V3 - PSP-23-02 -- Response to all the V2
written comments - Summary
Document, Engineering Memo, Parks &
Rec memo, Planning/Zoning memo.

Re: PSP-23-02 - Parker Ridge – 2nd Submittal review cycle
Response to Comments

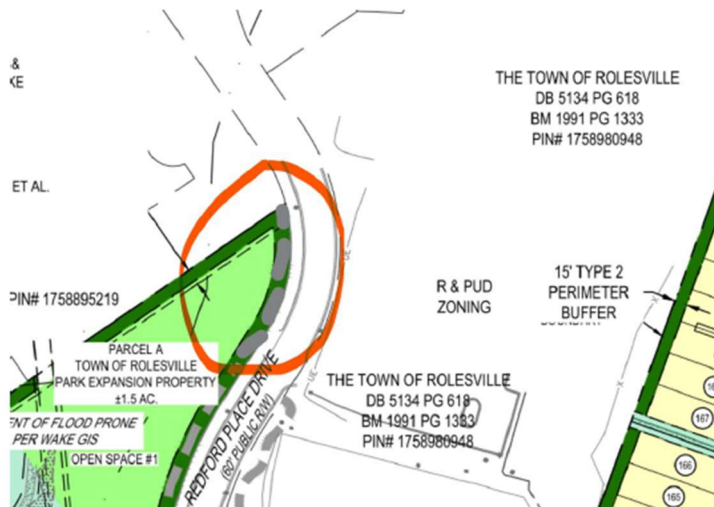
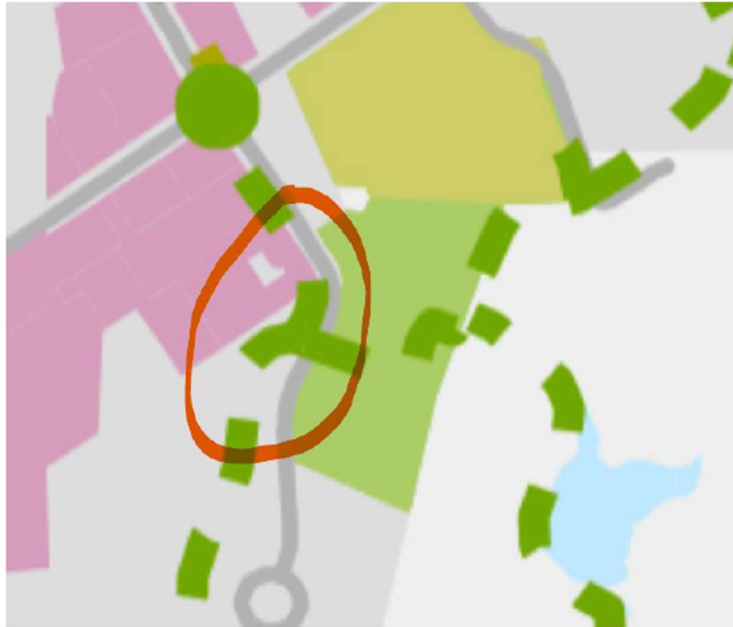
1. The Town would prefer the Greenway to be as close to the sidepath on Street H as possible. As shown currently on the concept plan, greenway users will have to cross the street twice to get onto the sidepath and ideally there is only one road crossing. Please revise the greenway that runs along the north side of the pond towards Long Melford Drive to align with the sidepath on Street H. It does look like there is a structure there (see Green highlighter circle below), is there any way to route the Greenway around this?

2. The Town's Greenway Plan shows that a greenway or sidepath continues north on this property towards Main Street. Please revise to show the sidepath continuing along Redford Place Drive until the property line.

Response: This section of greenway has been revised.

Response: This is now provided.

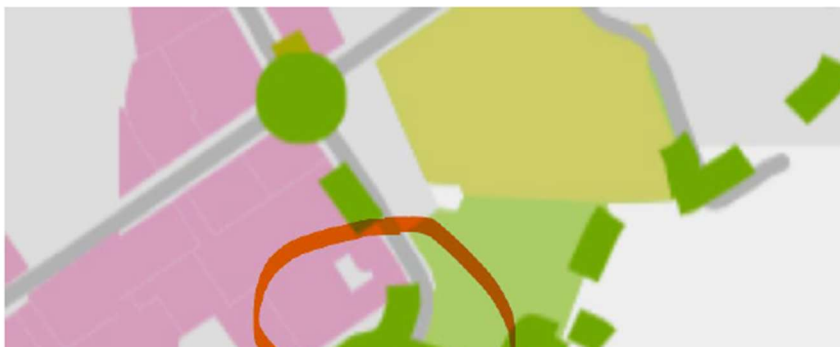
3. The Town's Greenway Plan shows the greenway on the west side of Redford Place Drive going through the property and connecting to Redford Place Drive. Please revise to show this greenway continuing to the road. The Town does not want a greenway to stub at to the future park property, but continue to the road.

Response: The greenway has been realigned to route around the existing wetland to the street.
